## **ATTACHMENTS**

Inspection Report for  
B-09-020

1050-01-11  
Chippewa Falls – Abbotsford  
Stillson Creek to Cardinal Ave  
STH 29  
Chippewa and Clark Counties  
Structure Photos

DOCUMENTATION RELATED TO  
CHANGE IN PROJECT SCOPE

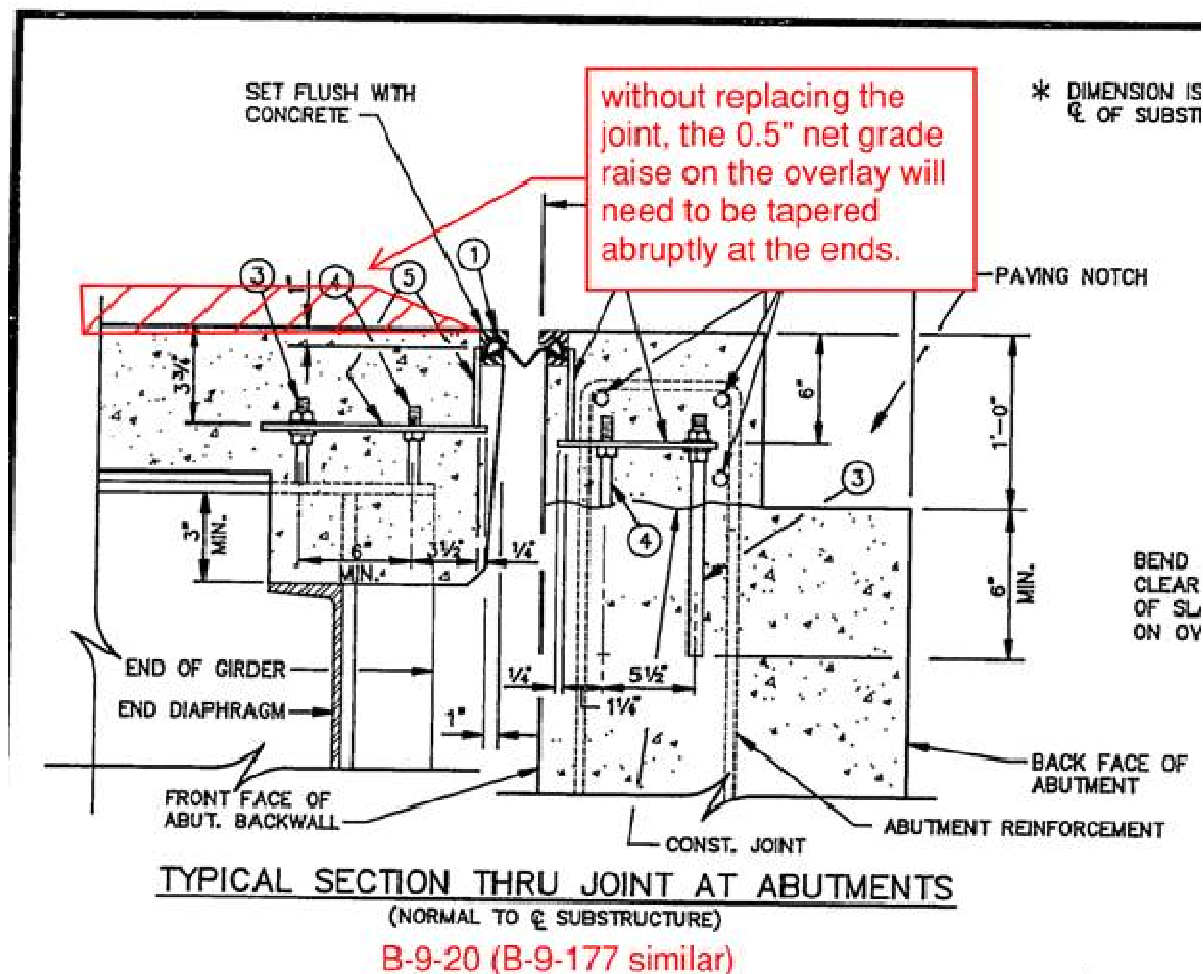
For steel girder bridges on ID 1050-01-11 (B-9-177 & B-9-20) we will have a 0.5" profile grade raise on the deck (see below). In many cases the joints get replaced on these. Without replacing the joint do we want to continue the overlay up to the joint, over the backwall, and then take out ½" raise in a taper in the asphalt? Or replace the joint?
